Agency Submissions

2014STH025 (RA14/1004)

Eco Tourist Resort

Kangaroo Valley Road, Bellawongarah

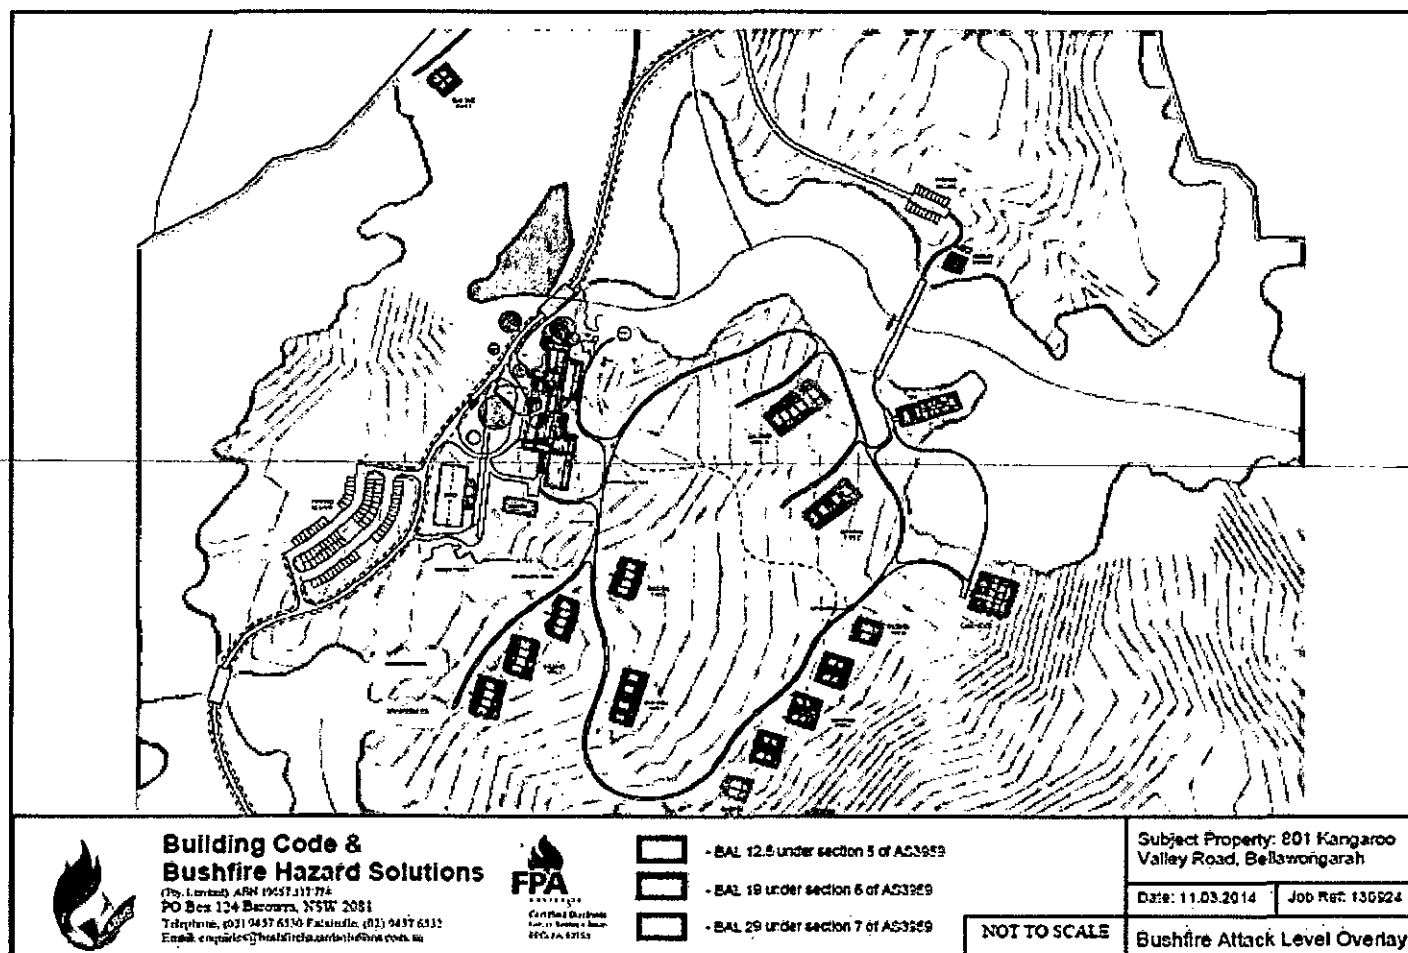
- 19. New accommodation cabins shall be constructed to comply with the Bushfire Attack Level under Australian Standard 3959 'Construction of buildings in bushfire-prone areas' 2009 and section A3.7 Addendum Appendix 3 of "Planning for Bush Fire Protection" as indicated on the Bushfire Attack Level overlay from the submitted Bushfire Hazard Assessment copied below:
